ISSUE: Permit to Demolish/Capsulate (partial) and Certificate of Appropriateness for alterations

APPLICANT: Cabell Hickman

LOCATION: Old and Historic Alexandria District
109 South Lee Street

STAFF RECOMMENDATION

2 PROPOSED FRONT ELEVATION
A401 SCALE: 1/4"=1'-0"

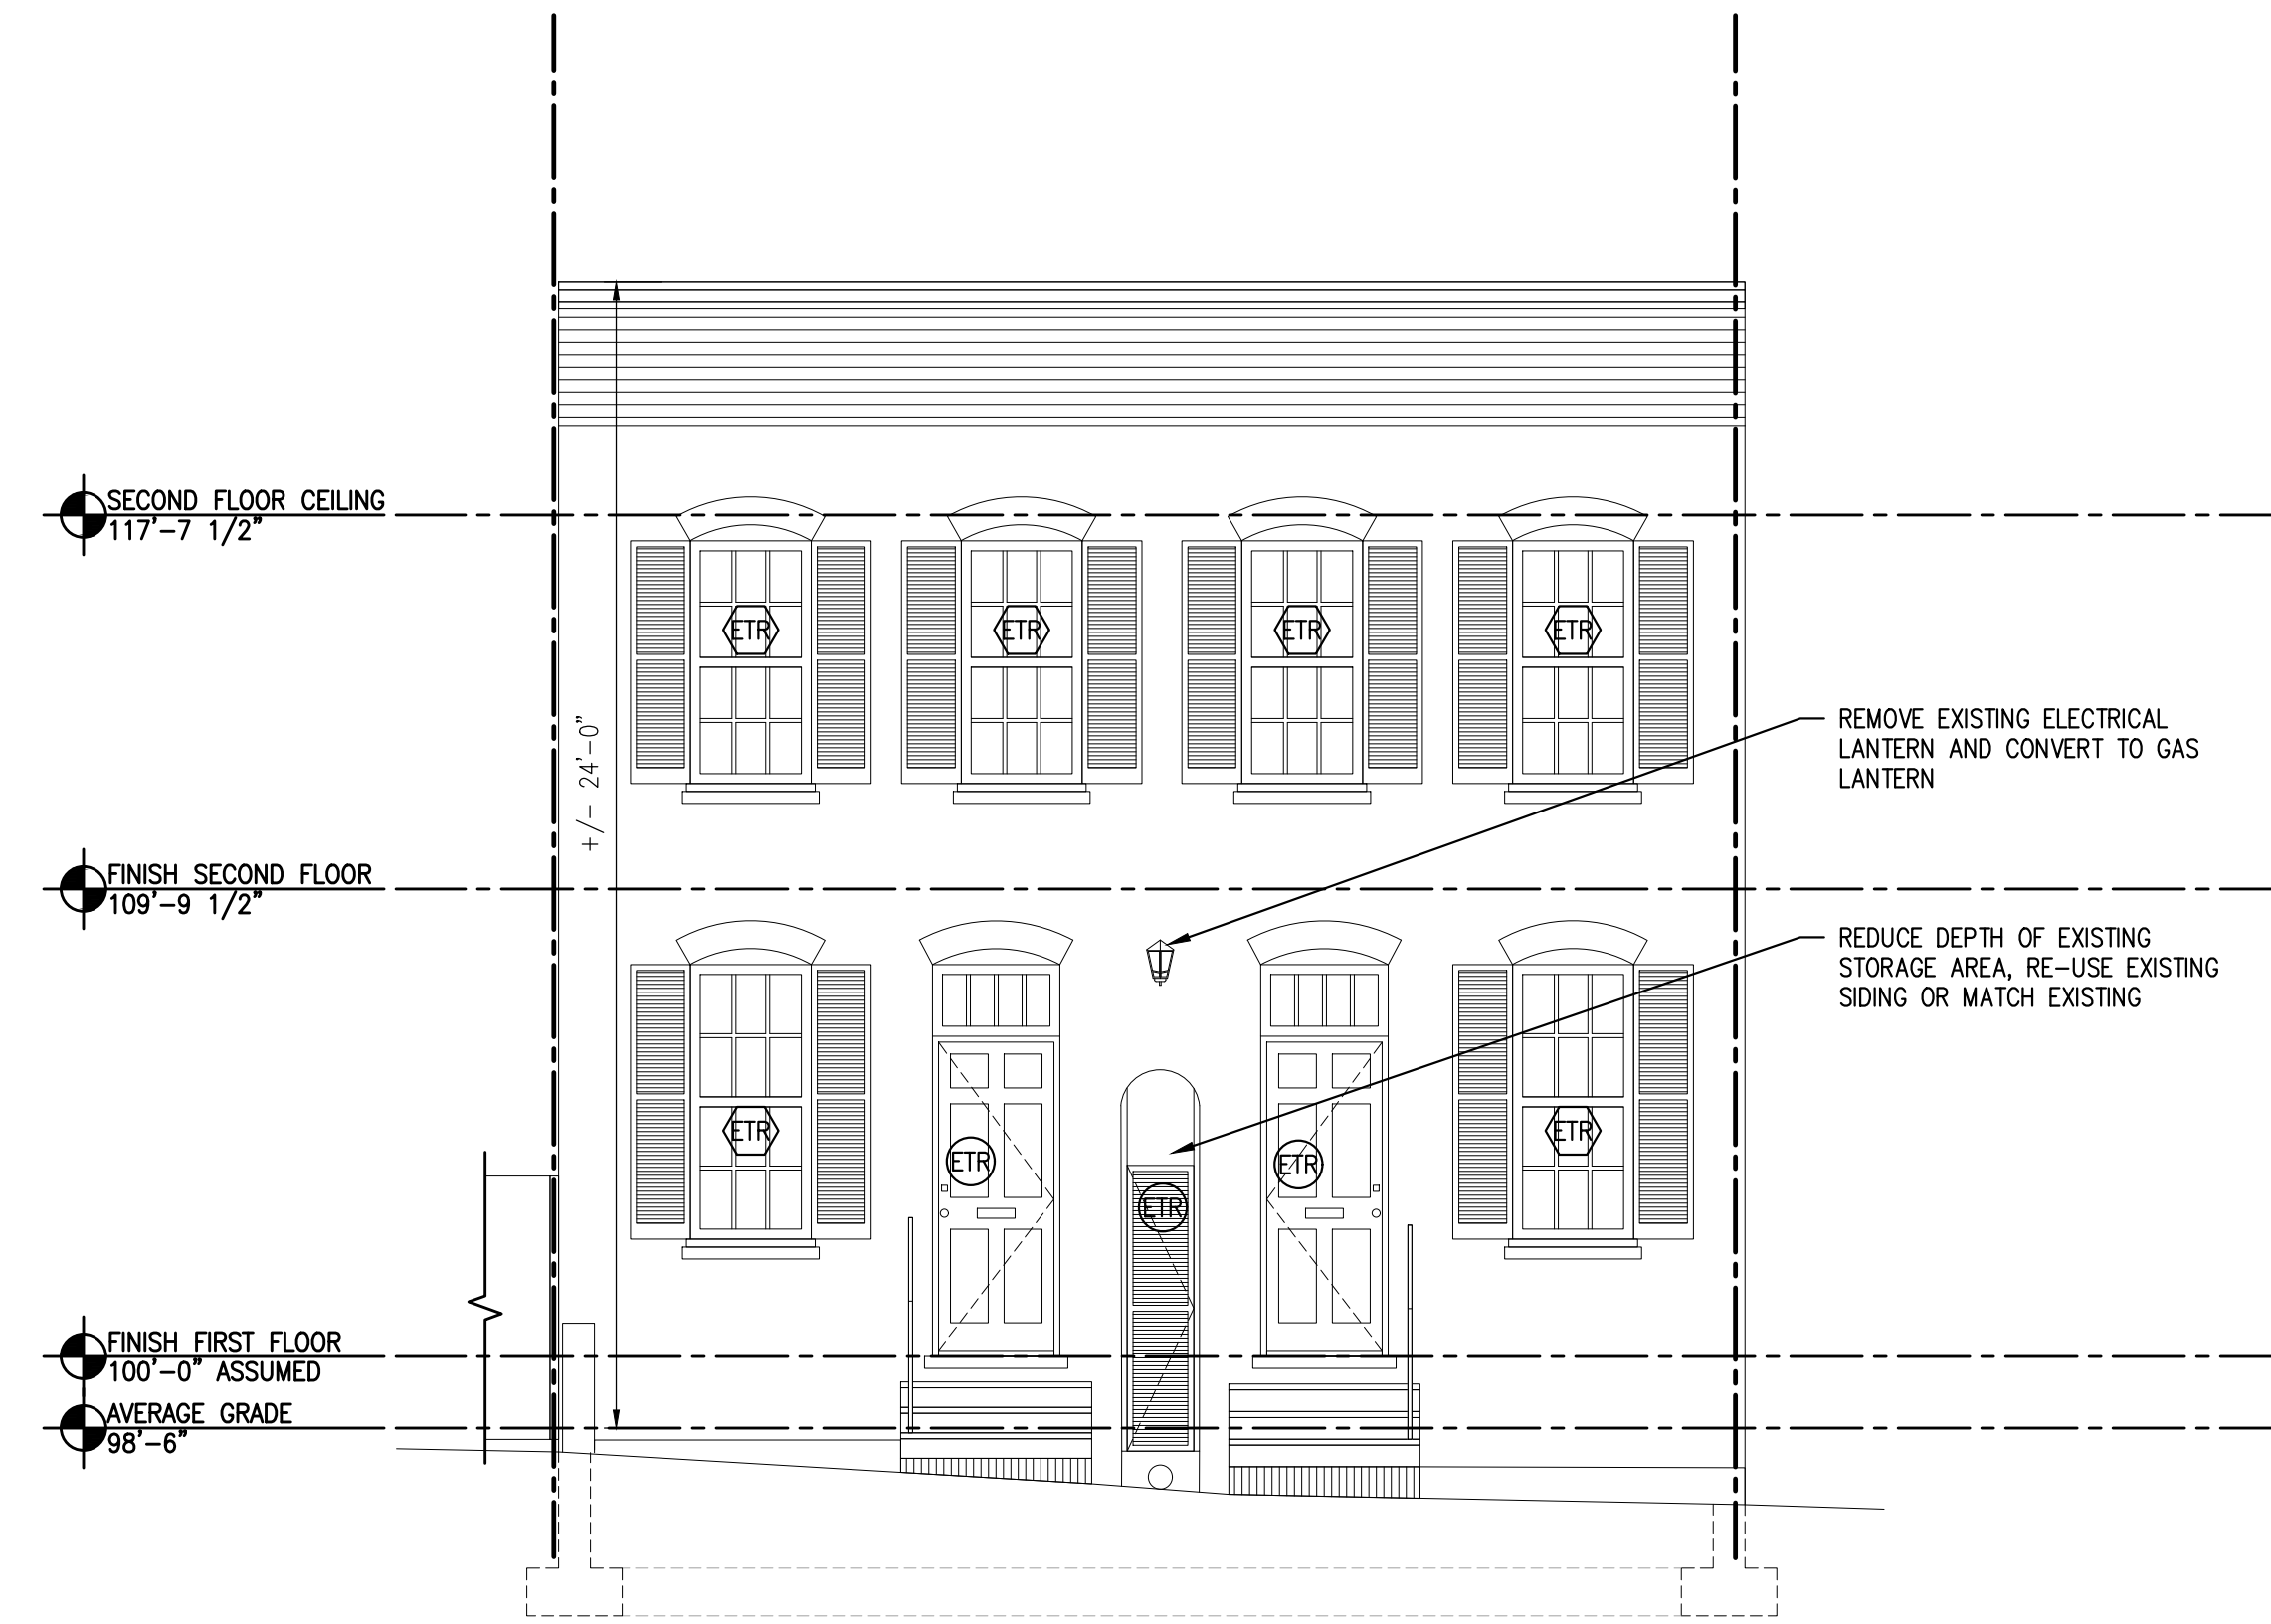
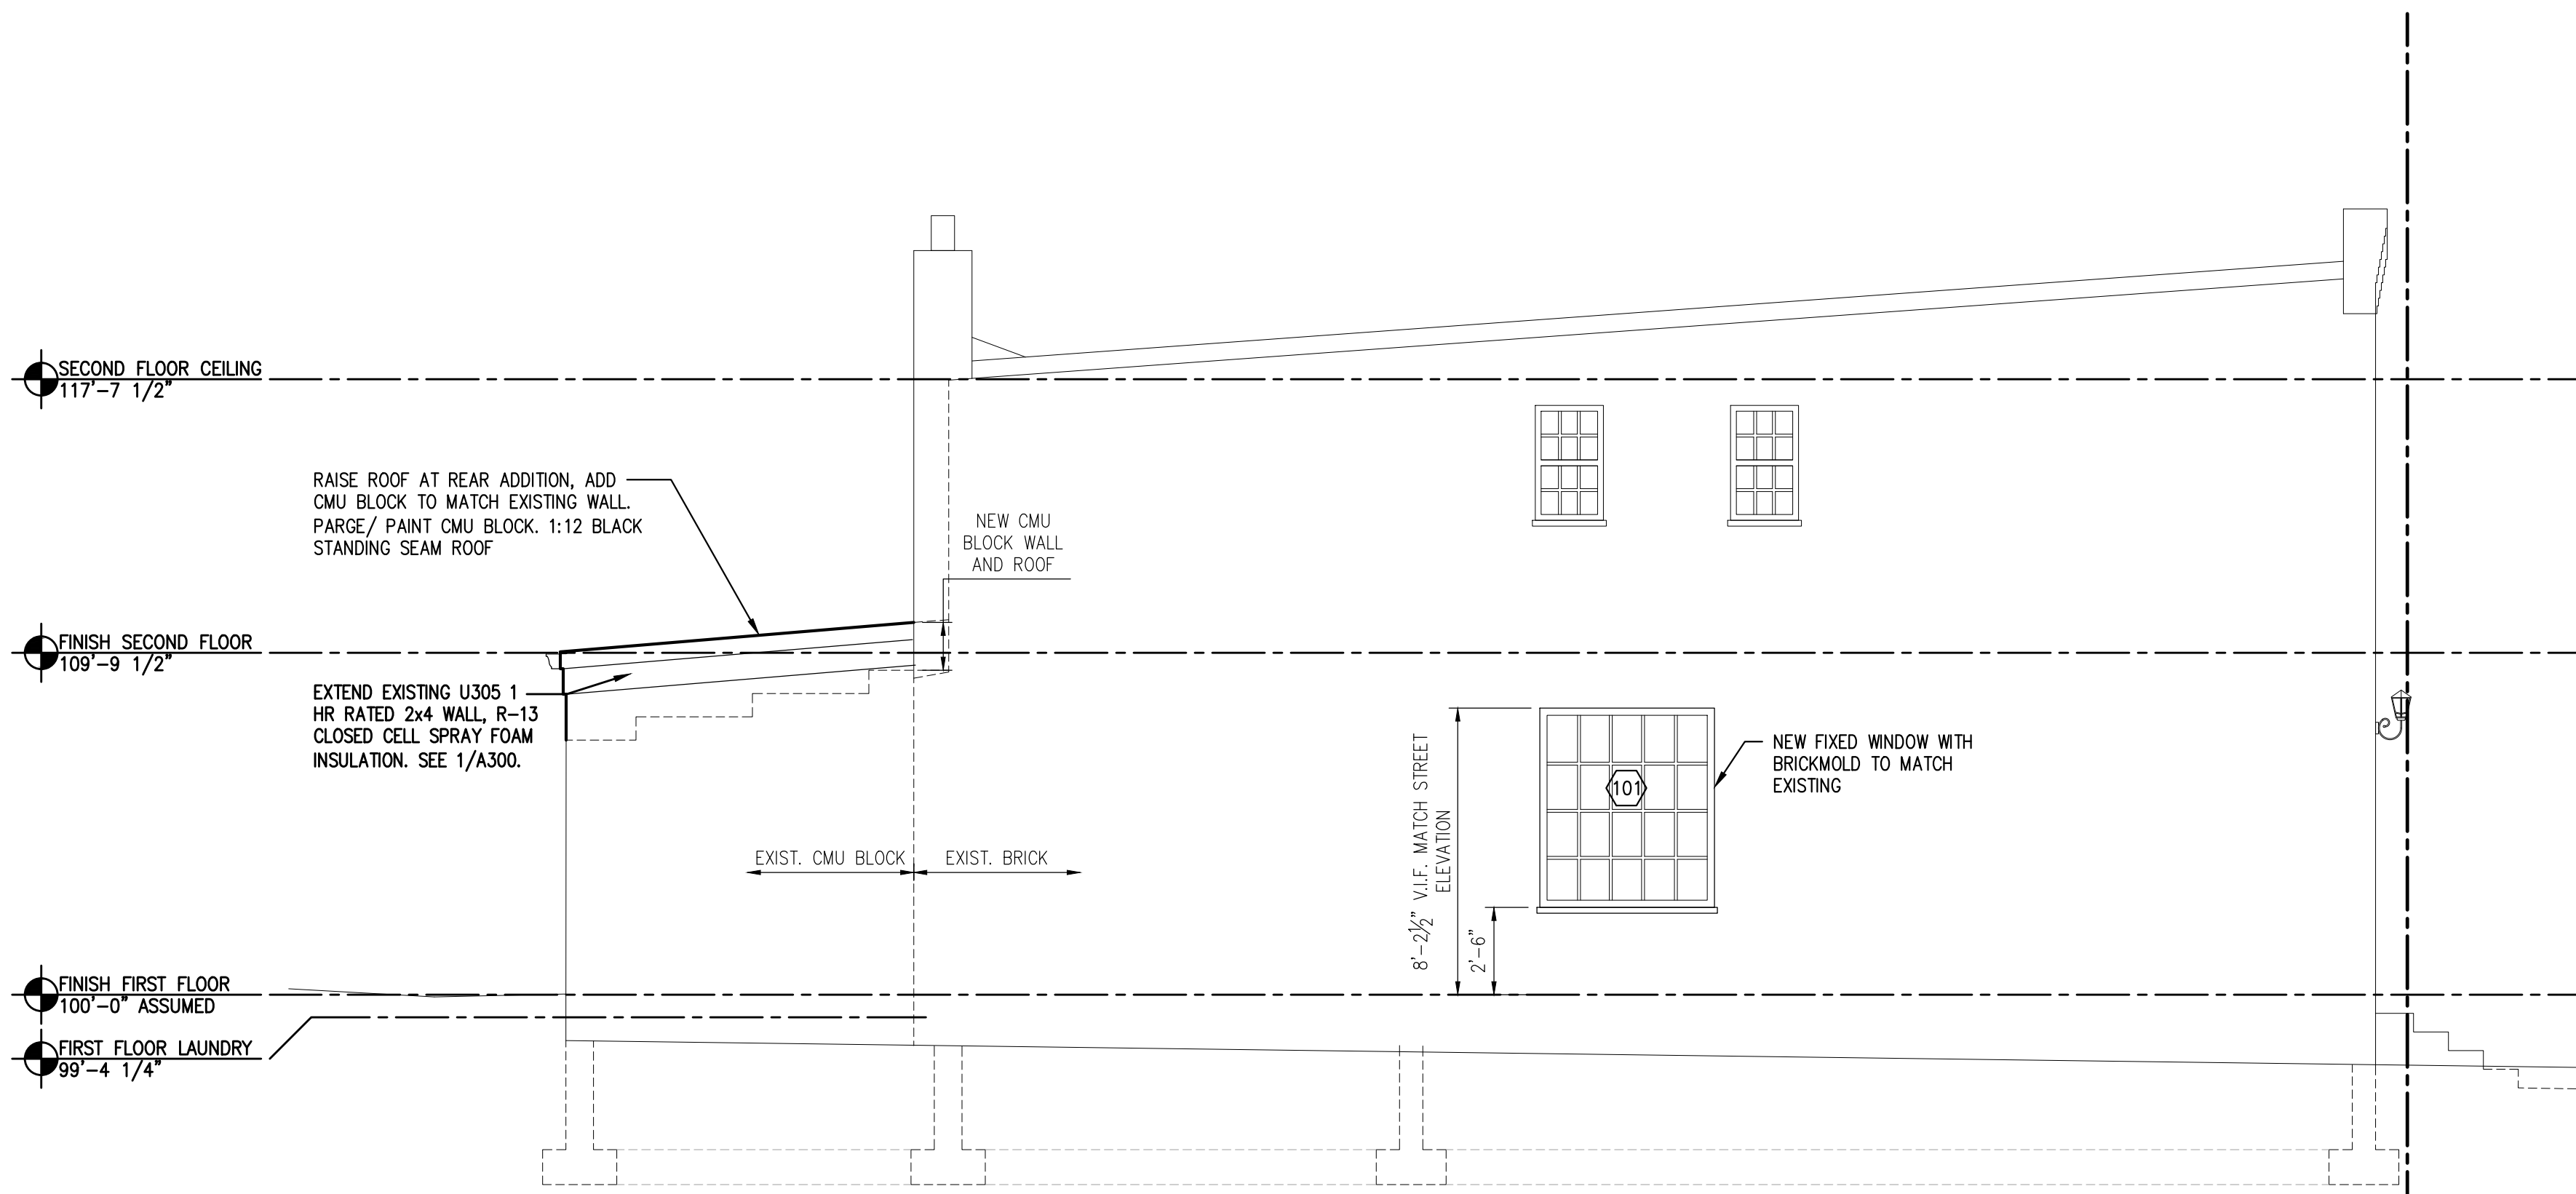
1. The new window on the south elevation complies with the City's *Alexandria New and Replacement Window Performance Specifications in the Historic Districts*
2. The applicant works with staff to choose the gas lantern design

- Insert a 5'-0" x 5'-8" fixed picture window on the first floor of the south elevation. The proposed wood window is double glazed, multi-pane, with sandwich muntins.

However, it is BAR policy that wood windows must be used on buildings and portions of buildings constructed before 1935 and that windows on secondary elevations may be double glazed provided that they have simulated divided lights (SDL), that is, muntins on the exterior. Therefore, staff recommends that the proposed window on the south elevation meets the *Alexandria New and Replacement Window Performance Specifications in the Historic District*.

- Replace an existing electrical lantern with a new gas lantern

Staff has no objection to the light fixture replacement on the building’s main façade as long it complies with the *Guidelines* which state that “While a certain level of exterior illumination is necessary for simple safety reasons during nighttime hours, care must be taken so that nighttime lighting does not produce inappropriate glare or misdirected light. The Board recognizes the importance of lighting after dark, but, at the same time, is actively discourage lighting which detracts from the appearance of the historic districts. For example, the Board has expressed concern about inappropriate decorative lighting on residential properties and lighting that is overly bright.”
